COMMISSION DIRECTIVE 2010/26/EU

of 31 March 2010

amending Directive 97/68/EC of the European Parliament and of the Council on the approximation of the laws of the Member States relating to measures against the emission of gaseous and particulate pollutants from internal combustion engines to be installed in non-road mobile machinery

4.3.1. Reference speed

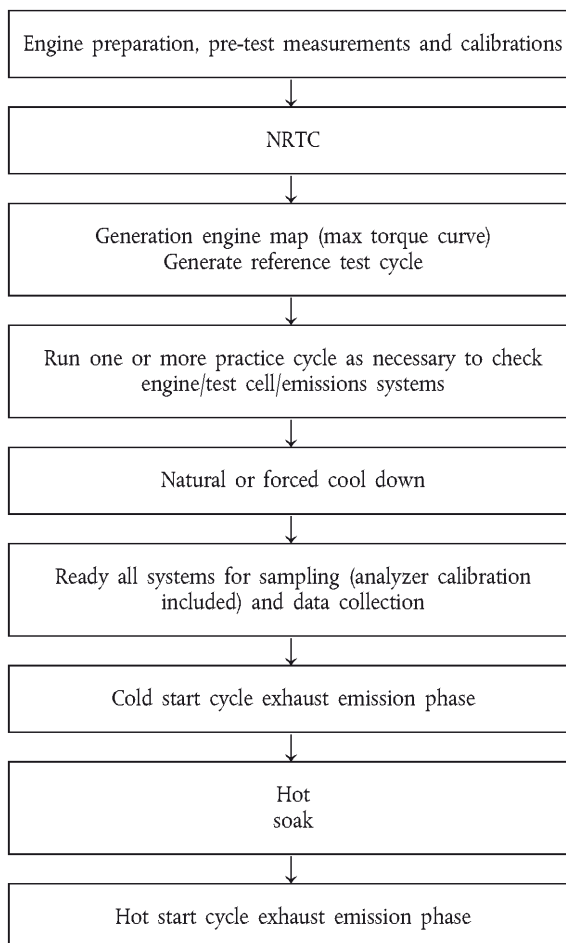
4. Section 4.3.1 is replaced by the following:

The reference speed (n_{ref}) corresponds to the 100 % normalised speed values specified in the engine dynamometer schedule of Appendix 4 of Annex III. The actual engine cycle resulting from denormalisation to the reference speed depends largely on selection of the proper reference speed. The reference speed shall be determined by the following formula:

$$n_{ref} = \text{low speed} + 0,95 \times (\text{high speed} - \text{low speed})$$

(the high speed is the highest engine speed where 70 % of the rated power is delivered, while the low speed is the lowest engine speed where 50 % of the rated power is delivered).

If the measured reference speed is within ± 3 % of the reference speed as declared by the manufacturer, the declared reference speed may be used for the emissions test. If the tolerance is exceeded, the measured reference speed shall be used for the emissions test ⁽¹⁾.
